Shearon Harris Nuclear Power Plant, Unit 1
Docket No. 50-400 / Renewed Facility Operating License No. NPF-63

Subject: REQUEST FOR LICENSE AMENDMENT
MEASUREMENT UNCERTAINTY RECAPTURE POWER UPRATE
COMMENTS REGARDING AMENDMENT 139

Enclosure: Retyped Technical Specification Page 2-2

REQUEST FOR LICENSE AMENDMENT
MEASUREMENT UNCERTAINTY RECAPTURE POWER UPRATE
RETYPED TECHNICAL SPECIFICATION PAGE 2-2

FIGURE 2.1-1
 REACTOR CORE SAFETY LIMITS – THREE LOOPS IN OPERATION
 WITH MEASURED RCS FLOW > [293,540 GPM X (1.0 + C₁)]

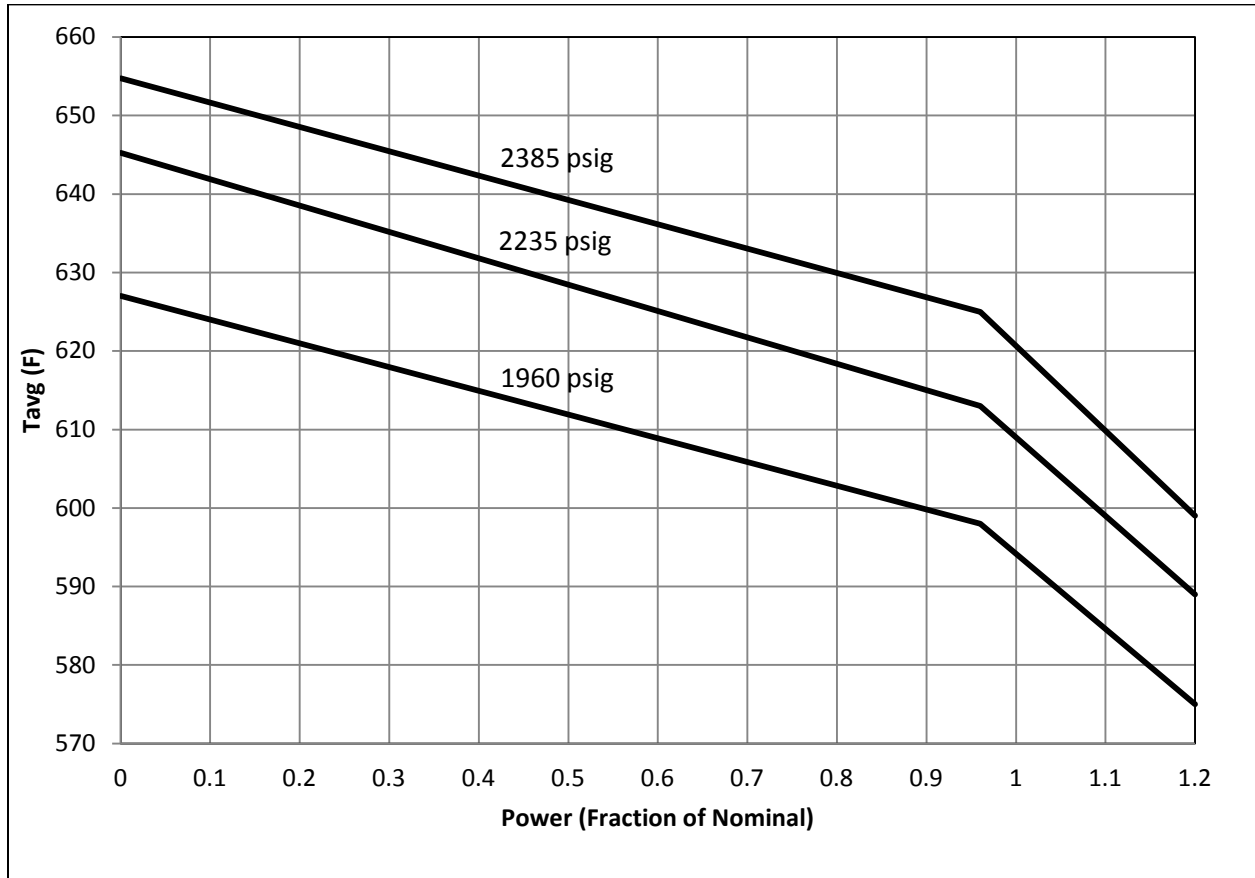
Reference 3, Safety Evaluation, page 67, Table 6 *Technical Specification Figure 2.1-1*, incorrectly correlates the highest pressure data set to a value of 2375 psig. The correct pressure for that data set is 2385 psig.

TS Figure 2.1-1, *Reactor Core Safety Limits*, contains curves of T_{avg} (RCS average temperature) versus Power at pressures of 2385, 2235, and 1960 psig. The data breakpoints corresponding to the curves were correctly provided in Reference 1, Enclosure 1, on page 4 of 18. A request for additional information (RAI) asked that we provide the current and proposed (post-uprate) breakpoints for the three Reactor Core Safety Limit curves. The RAI response, Reference 2, incorrectly identified the pressure corresponding to the upper curve as 2375 instead of 2385 due to a data transcription error from the calculation to the RAI response. The incorrect information was then carried forward from the RAI response to the Safety Evaluation (page 67, Table 6, *Technical Specification Figure 2.1-1*) resulting in correlating the upper curve of Figure 2.1-1, labeled 2385, to a data set incorrectly labeled 2375 psig. The three Reactor Core Safety Limit curves of Technical Specification Figure 2.1-1, both prior and subsequent to Amendment 139, are correctly labeled 2385 psig, 2235 psig, and 1960 psig.

A second error was discovered on the title of Technical Specification Figure 2.1-1 in Amendment 139. Figure 2.1-1, as issued, is titled *REACTOR CORE SAFETY LIMITS - THREE LOOPS IN OPERATION WITH MEASURED RCS FLOW $\geq [293,540 \text{ GPM} \times (1.0 + C)]$* . It should be “>” (greater than) instead of “ \geq ” (greater than or equal to).

The TS markup in the original LAR was correct, however the “>” sign was inadvertently changed to “ \geq ” in the retyped pages submitted in the LAR. This was caused by an administrative error when retyping the page to incorporate the changed figure (not intended to change the title). “>” is correctly cited in the discussion of Figure 2.1-1 in the LAR and the SE. Please issue a revised Technical Specification page 2-2, changing “ \geq ” to “>” in the title of Figure 2.1-1, supported by Reference 1, Enclosure, Attachment 1, *OPERATING LICENSE AND TECHNICAL SPECIFICATION PAGE MARKUPS*. The corrected retyped page is enclosed.

The impact is limited to the one number (2375) in Table 6, and does not affect the discussion of how the curves were developed in our LAR, its supplements, or the discussion in the Safety Evaluation. Please issue a revised page 67 to the Safety Evaluation, replacing 2375 with 2385 in Table 6, *Technical Specification Figure 2.1-1*, supported by the correct information in Reference 1.
